Our Ref: R/2014/39/J  
File No: 2018/600170  
Your Ref: SSD 7484 MOD 3

**Modification Application – The Sandstone Precinct – SSD 7484 (MOD 3), 23-33 & 33-35 Bridge Street, Sydney**

### **Ground floor function room**

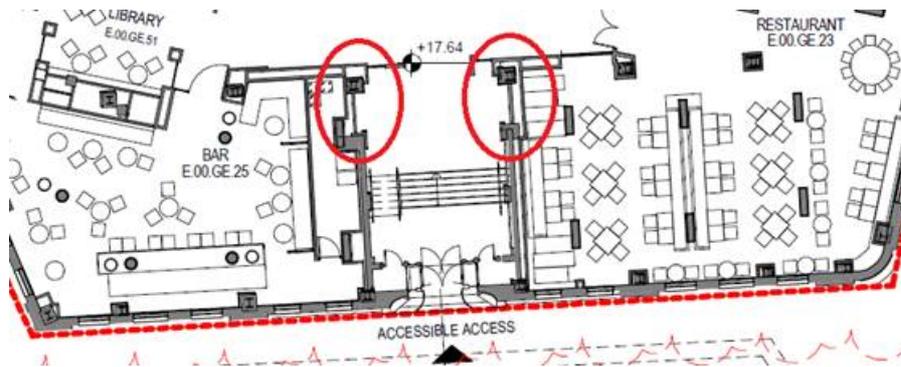
The demolition of the existing wall between ground level function rooms 8 and 9 shown on proposed plan SP-DA-G-2500 is **not supported**. These rooms are of exceptional significance and the proposed demolition will destroy original fabric and disrupt the proportion of the rooms. The proposed operable wall or multiple modern doors (plans are ambiguous) are not acceptable. The single door between these rooms in the approved design provides sufficient connection between the rooms, particularly given that function room 9 is designated as a private function room. This proposed modification is, therefore, **not supported**. [Note that the Heritage Impact Statement appears to have an error. It does not mention the demolition of the wall between function rooms 8 and 9 shown on the plans, and discussed above, but mentions deletion of an opening between Function Room 8 and 10 which is not shown on the plans].
